Ordinary Meeting of the Council

Date: Tuesday, 24 November 2020

9.2	Planning Application PLN20/0146 at 530-532 Doncaster Road Doncaster, for the use and development of the land for a five-storey mixed use building comprising 22 dwellings, a medical centre and the creation and alteration of access to a road in a Road Zone, Category 1	
10	CITY	PLANNING & COMMUNITY	197
11	CITY	SERVICES	197
12	SHAF	RED SERVICES	197
13	CHIE	EXECUTIVE OFFICER	198

9.1 Planning Application PLN20/0030 at 9-11 Clay Drive, Doncaster, for the construction of a five-storey apartment building comprising 36 dwellings, associated basement car parking and a visitor car parking waiver of two spaces.

Figure 5 – Downward views to the south from the balcony at third floor level.

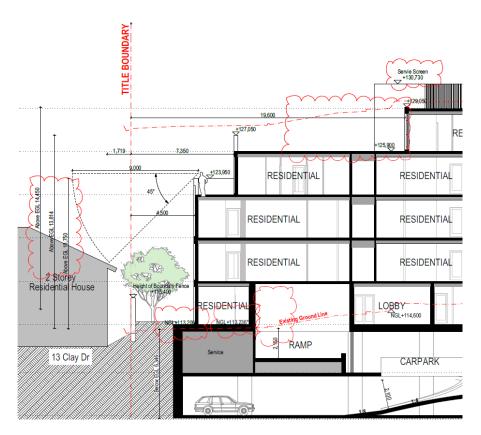
- 8.17 Habitable room windows and balconies on the southern and western elevations at the third and fourth floor level would not be screened, however direct downward views are limited. There are no direct downward views to the ground surface level of the secluded private open space areas of 13 Clay Drive (south of the site) and 8 Frederick Street (west of the site) within 9 metres of the balconies at third floor level. At fourth floor level, 800 mm wide planters would be provided within the balconies further limiting downward views to the south and west of the site (see Figures 5 & 6 below).

- 8.18 The development therefore provides the appropriate level of screening, striking a balance between privacy and outlook, thereby reducing the need for visually bulky screens at the third and fourth floor levels.
